File FP-1995-139

TITLE HEADING: Final Plan - Ernst Storage

Re: Ernst Storage-Final Plan, Response to Review Comments, File #FP-95-139.

FILE: #FP 95-139  
DATE: August 16, 1995  
STAFF: Michael Drollinger  
REQUEST: Final Plan - Ernst Hardware  
LOCATION: E Side of 28 1/4 Rd, N of North Avenue  
ZONING: PC

# ERNST STORAGE YARD TRAFFIC CIRCULATION PLAN

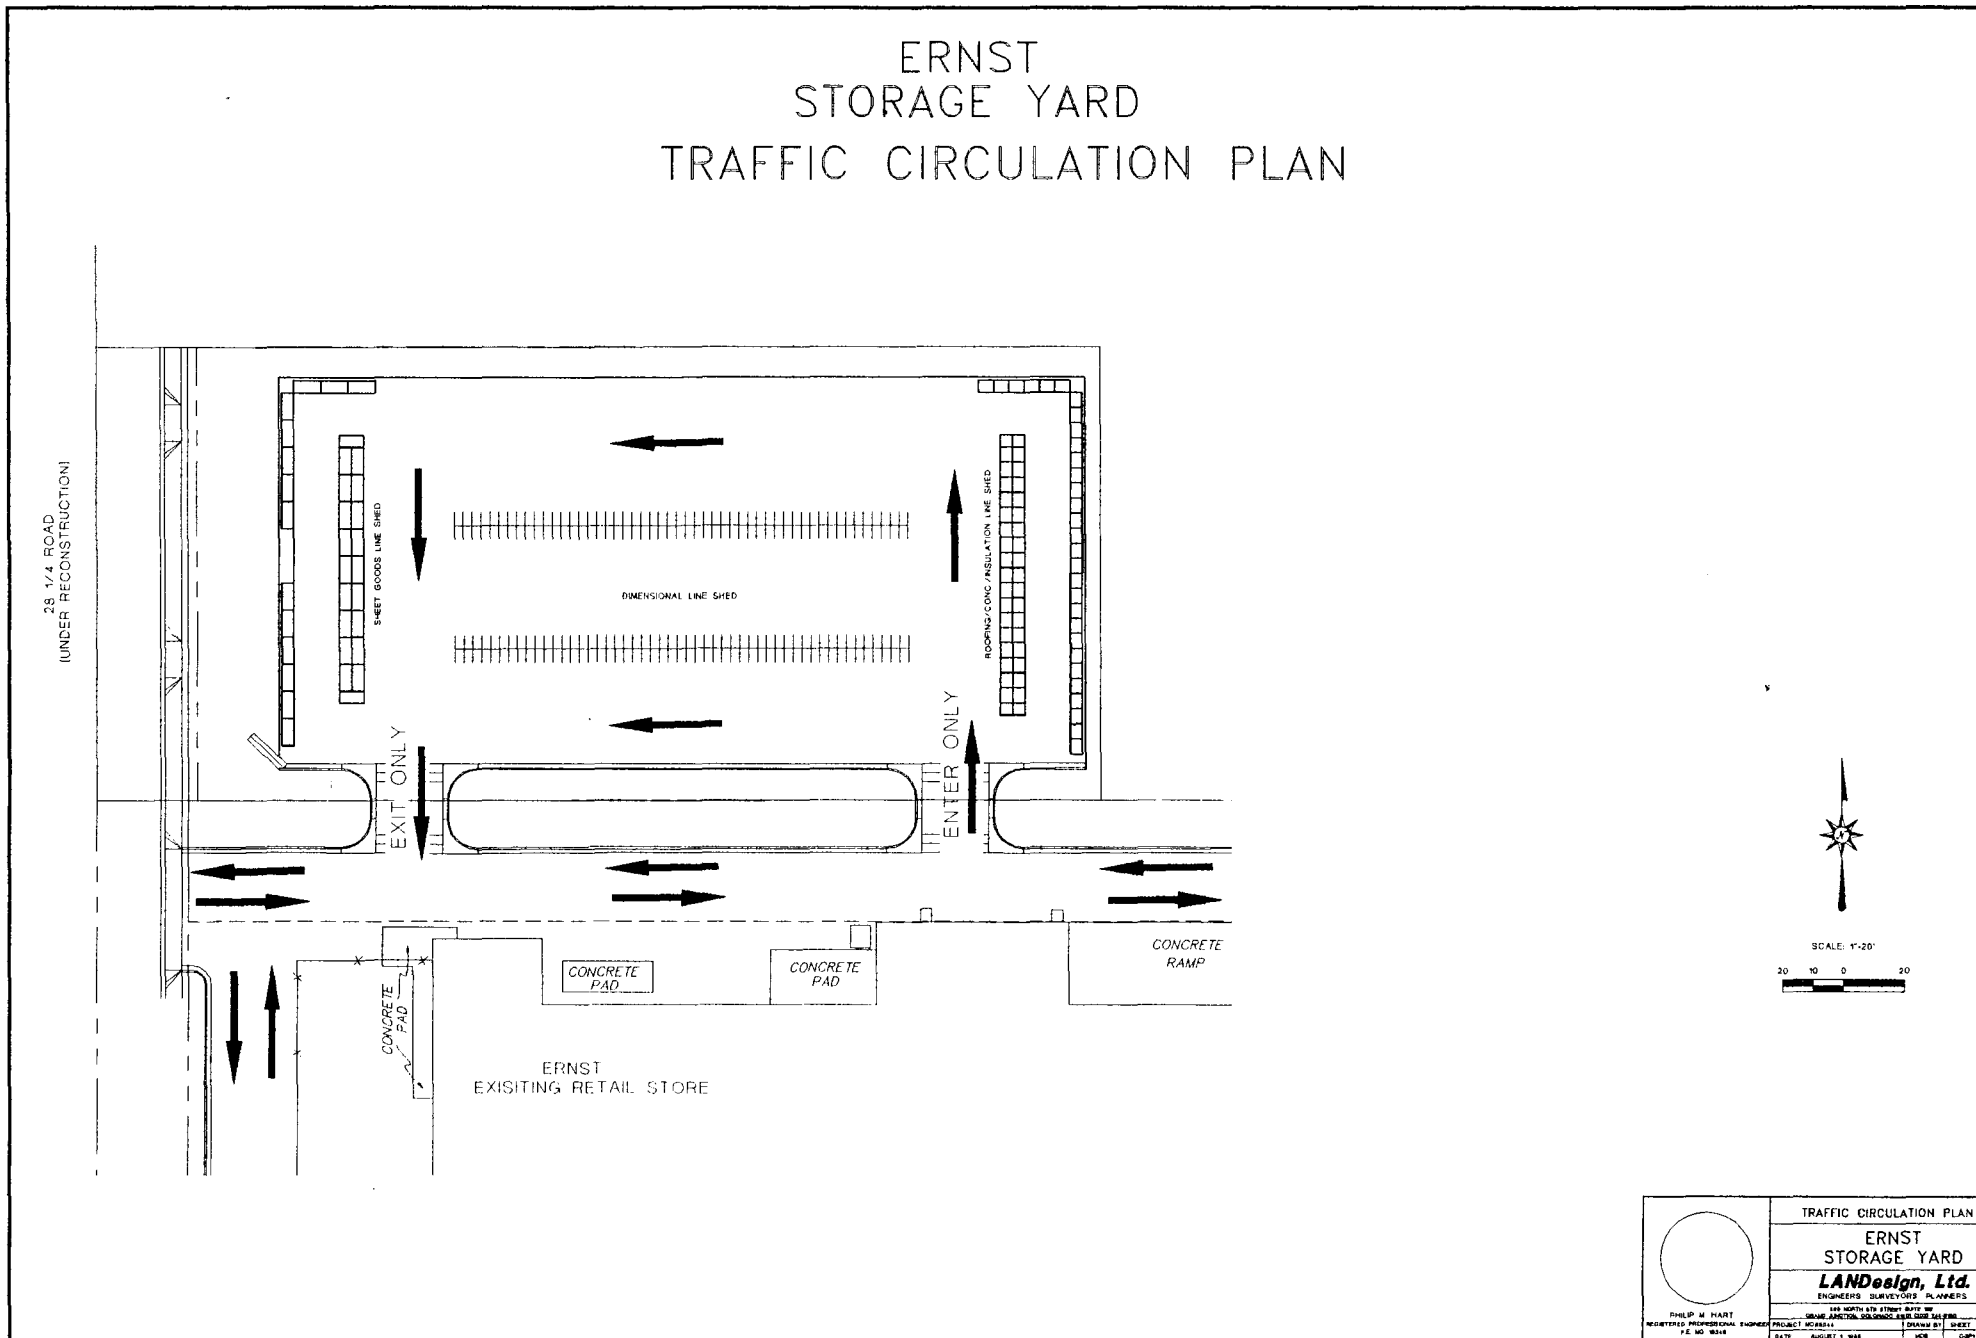
2. Will the storage yard be signed and marked as indicated on the submitted Traffic Circulation Plan? The plan should reflect what will actually be done on-site be showing size and placement of markings and signs. Will parking be prohibited along the back of the store?

SECTION A-A  
TYPICAL LANDSCAPE SECTION

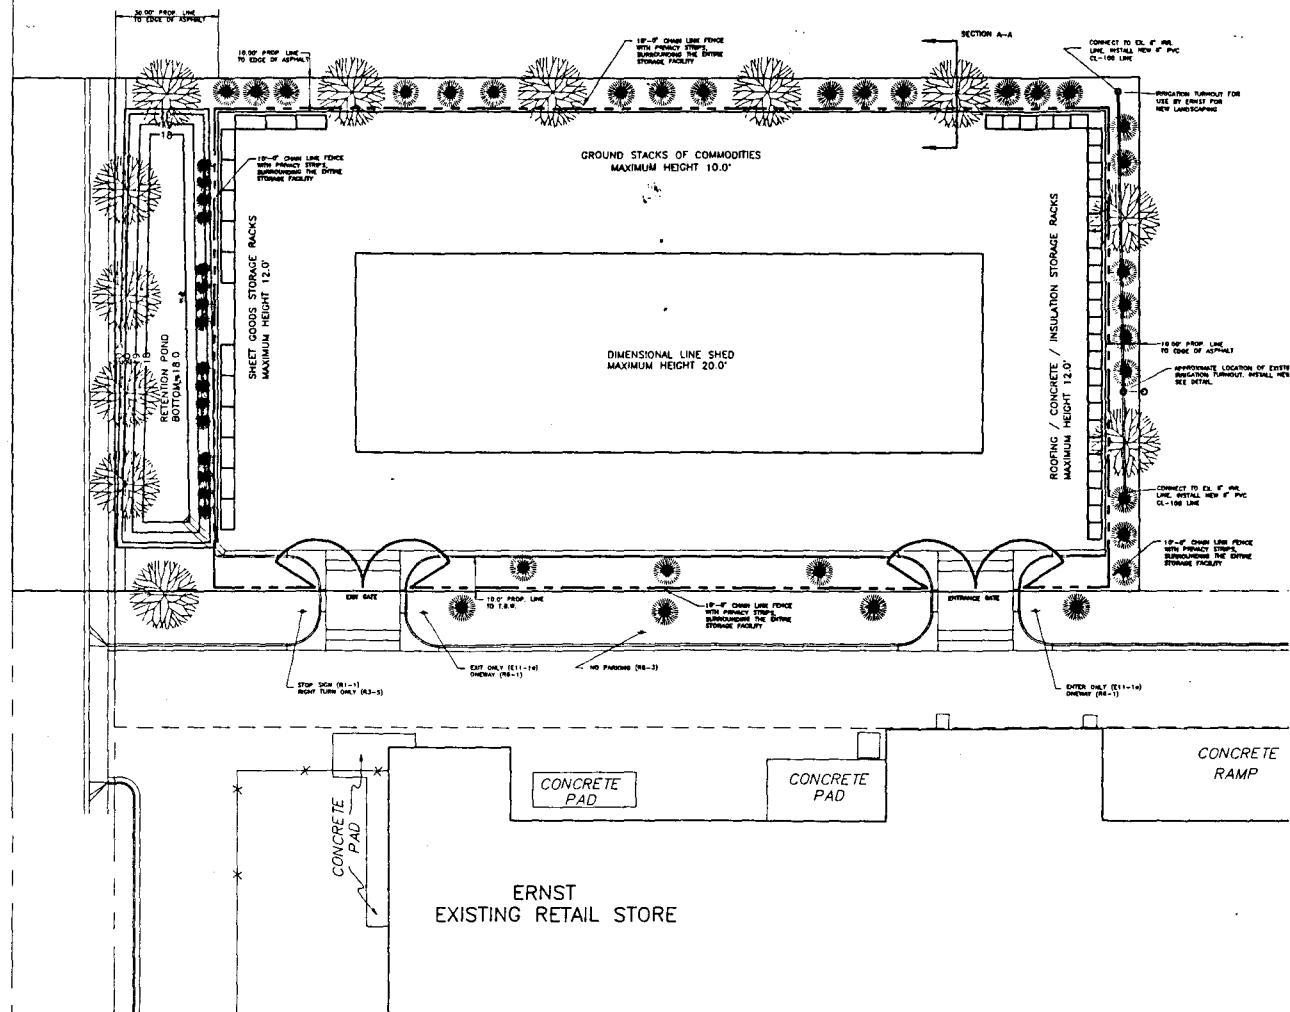
1. Landscaping section drawing shown on plan is not labeled or identified on plan.
2. Plant Material Legend is incomplete; refer to SSID manual requirements.
3. Note #2 shall be deleted; City has not adopted Mesa County specifications.
4. Please correct grammatical error in Note #1.
5. Clearly identify the location of the proposed fence on ALL PLANS.
6. Landscape strip on east side of project shall be at least ten (10) feet wide. Trees shall also be planted along this side.
7. No trees or shrubs shall be located within the retention pond; please revise plan.
8. Curb cuts along 28 1/4 Road identified on plans have not been installed and therefore do not require removal; please revise ALL plans accordingly.

✓ 1. The landscaping section has been labeled and it's location identified on the plan.

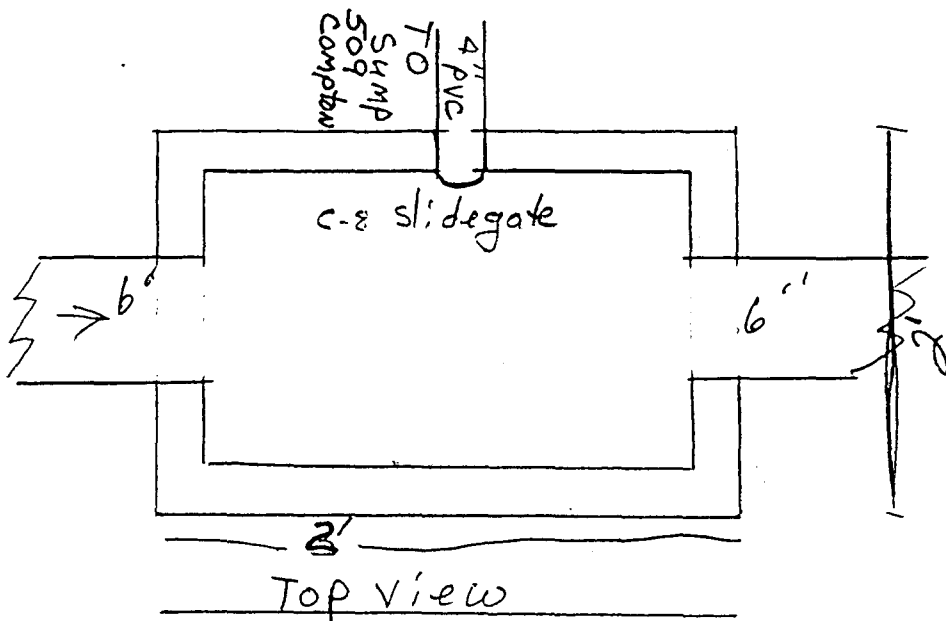
Re: This Project! No surface drainage will be allowed into Association ditch/pipe. Existing ditch (approx) 100' must be replaced with a 6" PVC 100# pipe. In addition, developer will install an irrigation turnout per the attached drawing. The turnout will be equipped with 1 each C-8 4" headgate 1 each 1/4" steel lid. All per the attached drawing. This portion of the entire project cannot be begun before November 1, 1995 as irrigation water will be in the ditch till that date. Met with representative of Landesign on 8/8/95 to discuss irrigation ditch requirements. Drawing depicts items agreed to.

The Site Plan has been revised to show a new irrigation turnout detail as requested. The specifications for material types to be used are included on this detail in keeping with the associations requirements.
